9.4 Air Conditioning, Heating, Cooling and Ventilating Systems

The information in this section of the reference ABWR DCD, including all subsections, tables, and figures is incorporated by reference with the following departures and supplements.

Figure 9.4-2c Turbine Building Electrical Equipment Areas (EEA) HVAC System Diagram

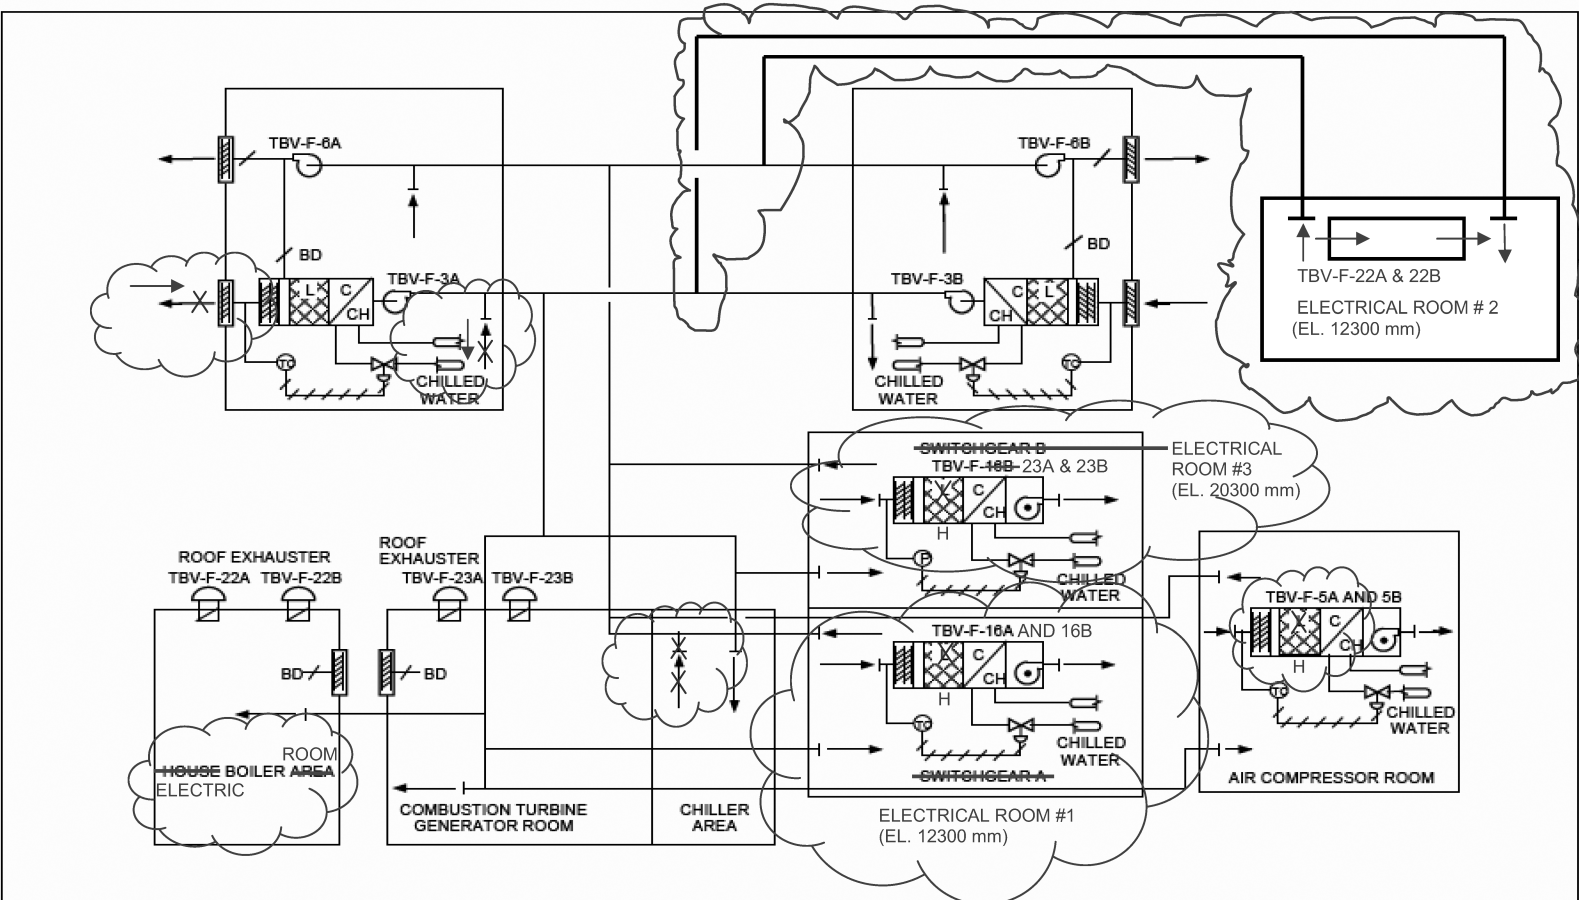
The ~~E/B~~ EEA HVAC schematic diagram is shown on Figure 9.4-2c.
